UNITED STATES  
**NUCLEAR REGULATORY COMMISSION**  
REGION IV  
1600 EAST LAMAR BLVD  
ARLINGTON, TEXAS 76011-4511

July 18, 2012

**SUBJECT: SAN ONOFRE NUCLEAR GENERATING STATION – NRC AUGMENTED  
INSPECTION TEAM REPORT 05000361/2012007 and 05000362/2012007**

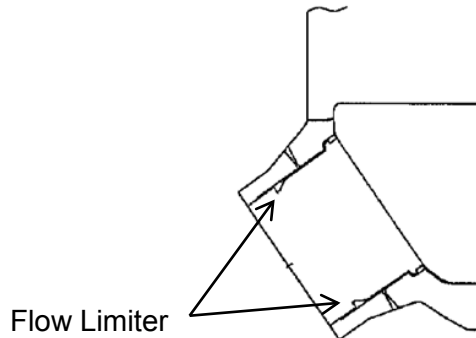
- Preliminary and ASME Section III Hydrostatic Tests – The number of hydrostatic tests performed in accordance with ASME Section III on the primary and secondary sides of the replacement steam generators varied between Units due to the results of the initial test in each steam generator. For each replacement steam generator, the hydrostatic tests were performed first on the primary side and then on the secondary side. Both Unit 2 steam generators met the acceptance criteria in the first hydrostatic test. However, during the first hydrostatic test on the secondary side of Unit 3 steam generator 3E0-89, Mitsubishi identified leakage through a tube-to-tubesheet weld that exceeded the ASME Code acceptance criteria. After repairs were completed to address the leakage, the hydrostatic tests were re-performed. Following the second set of hydrostatic tests on Unit 3 steam generator 3E0-89, cracking indications were identified in the divider plate-to-channel head weld. After repairs were completed to address the divider plate weld cracks, a third set of hydrostatic tests were performed in Unit 3 steam generator 3E0-89. Since similar cracking indications

of the divider plate weld were identified in Unit 3 steam generator 3E0-88, a second set of hydrostatic tests was performed in this steam generator after the divider plate weld was repaired.

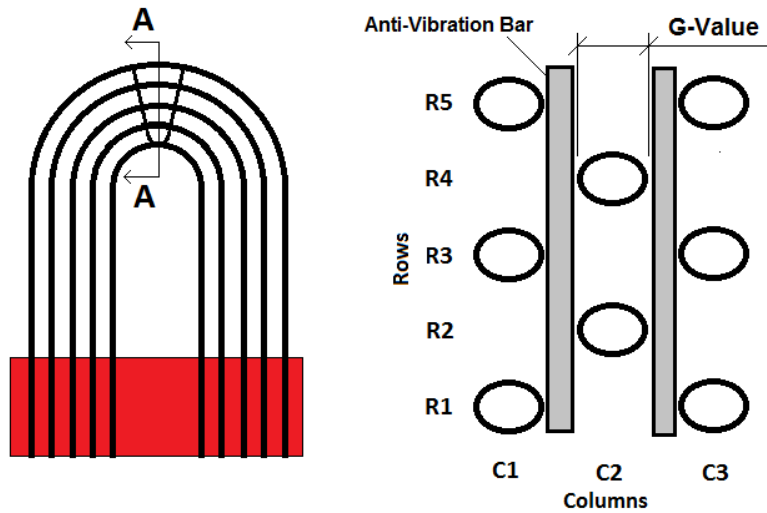
- Anti-Vibration Bar Spacing Issues in Unit 2 Steam Generator 2E0-89 – During fabrication of Unit 2 replacement steam generator 2E0-89, quality control inspections identified unacceptable gaps between tubes and the anti-vibration bars in the outside tube columns. The affected area was identified as welding zone-4. The apparent cause for the anti-vibration bar spacing issue was due to performing the welding of zone-4 while the steam generator was oriented horizontally with this welding zone oriented to the bottom of the bundle. In this configuration, the tube bundle experienced sagging at the time of welding due to gravity. After completion of welding zone 4, the steam generator assembly was rotated 180 degrees for additional assembly steps, but the sagging in the opposite direction caused enlargement of the gaps in welding zone 4 and this enlargement remained approximately the same for all subsequent rotations. When zone-4 was rotated 180-degrees after welding, deflection or sagging of the tube retaining bars due to gravity slightly pulled the anti-vibration bars, increasing the gap between the tube and the anti-vibration bars in this zone.

With the licensee’s approval, Mitsubishi implemented various corrective actions to address the condition in the pending Unit 2 replacement steam generator 2E0-88 and subsequently in Unit 3 steam generators which included: (a) use of smaller spacer blocks between tubes for the installation of anti-vibration bars, (b) re-define the welding zones to limit welding in the horizontal position, and (c) reduce rotations during welding of the other bundle zones. Mitsubishi performed rework activities in Unit 2 steam generator 2E0-89 to restore anti-vibration bar spacing to design specifications. These activities resulted in better gap distribution. All the tube-to-anti-vibration bar gaps exceeding the initial dimensional criteria were further evaluated and accepted in accordance with Mitsubishi’s gap size evaluation procedure.

Figures 1 through 4 (different view angles of same results) show results, with low  $T_{hot}$  and low steam pressure and present a 3D isometric encapsulation of steam qualities (red scale) at and above 0.9 (i.e., void fraction > 0.99) and field velocities at and above 6.0 m/sec (white scale).

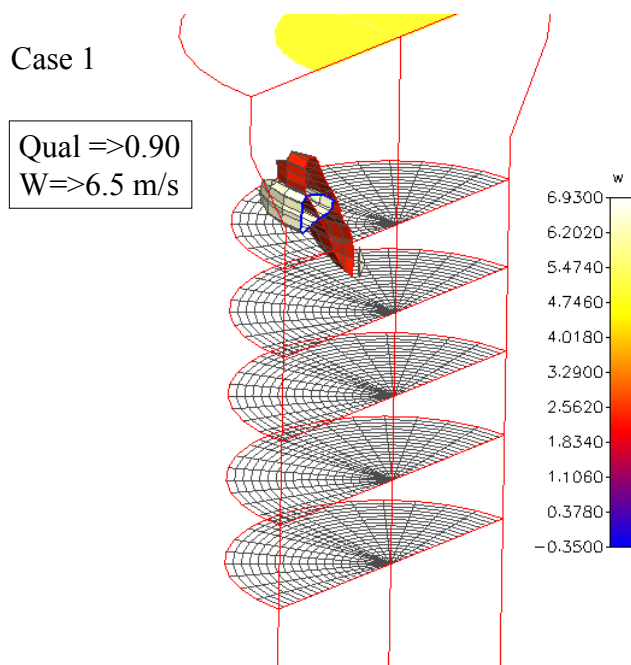
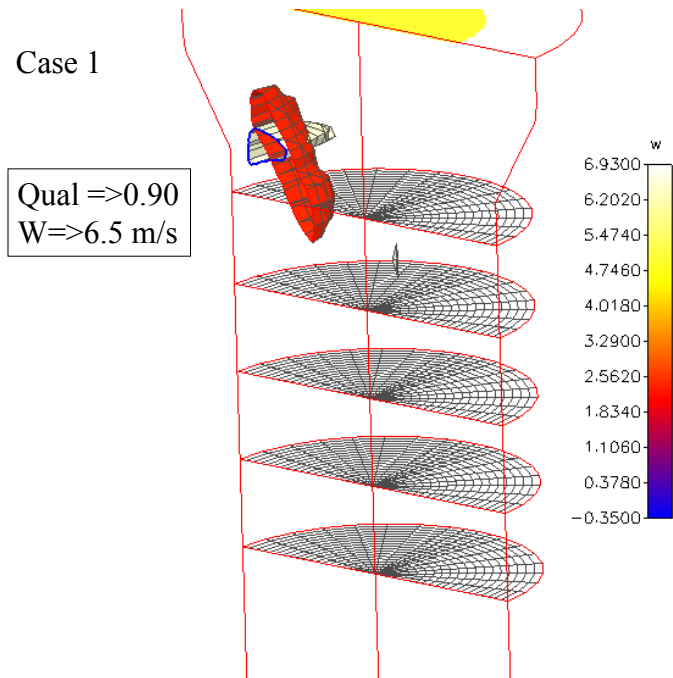
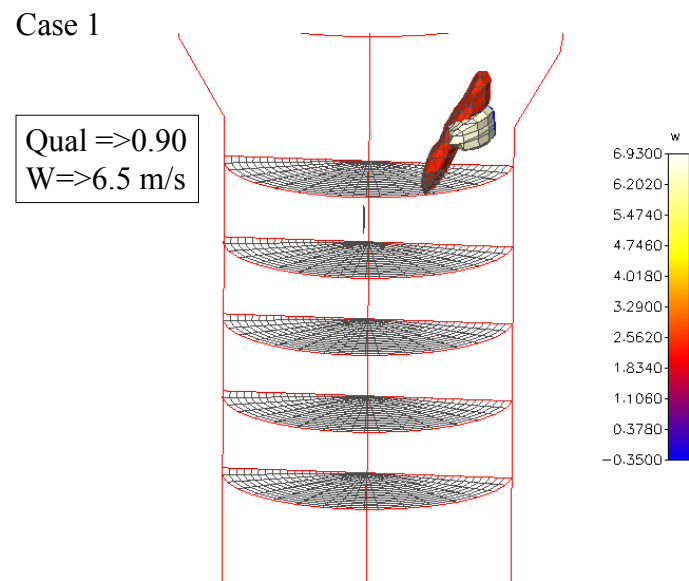
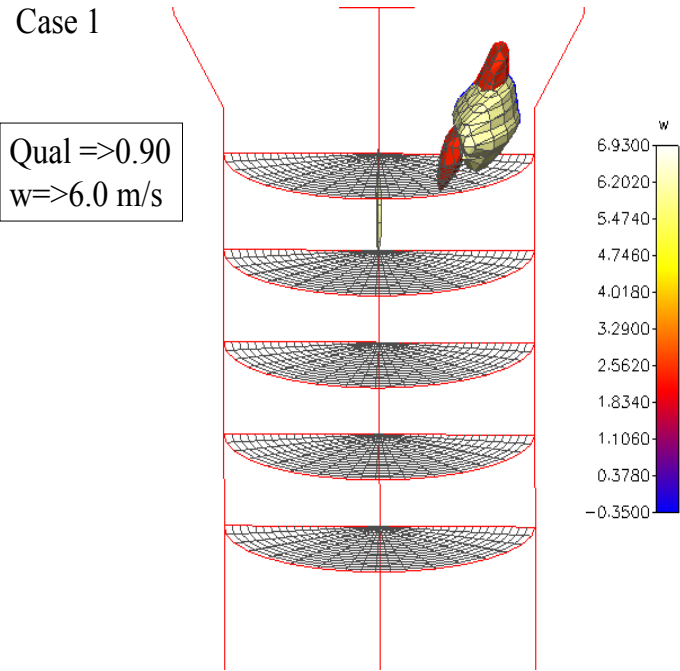
The ATHOS model results of high steam quality and steam velocity closely align with the area of concern (tube-to-tube wear) in the Unit 3 replacement steam generators. In Figure 5, the code predicted regions of high void fraction and high steam velocities (vertically located z-axis cut at about 20 inches above the 7<sup>th</sup> TSP) are superimposed with tube-to-tube wear indications from Unit 3 steam generator 3E0-88.

**Figure 5**

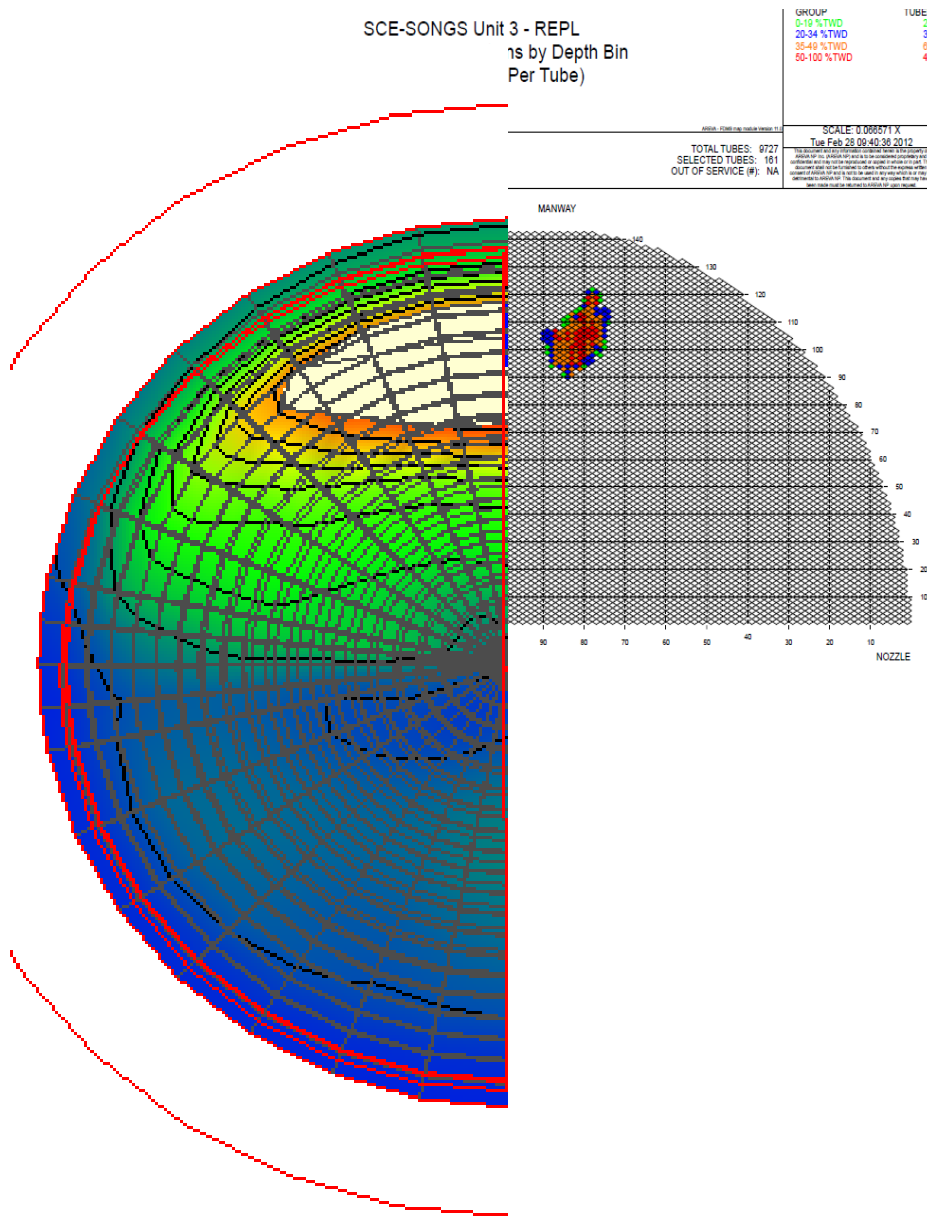
The ATHOS code predicted regions of high void fraction and high steam velocities are superimposed with tube-to-tube wear indications from Unit 3 steam generator 3E0-88

The NRC analysis indicated a correlation with the tube-to-tube wear based on a combination of high void fraction and high steam velocities. It should be noted that the traditional forcing function, fluid velocity squared times density, does not show good agreement with the tube-to-tube wear patterns. This indicated that the high quality steam fluid velocities and high void fraction may be sufficiently high to cause conditions in the generators conducive for onset of fluid-elastic instability.
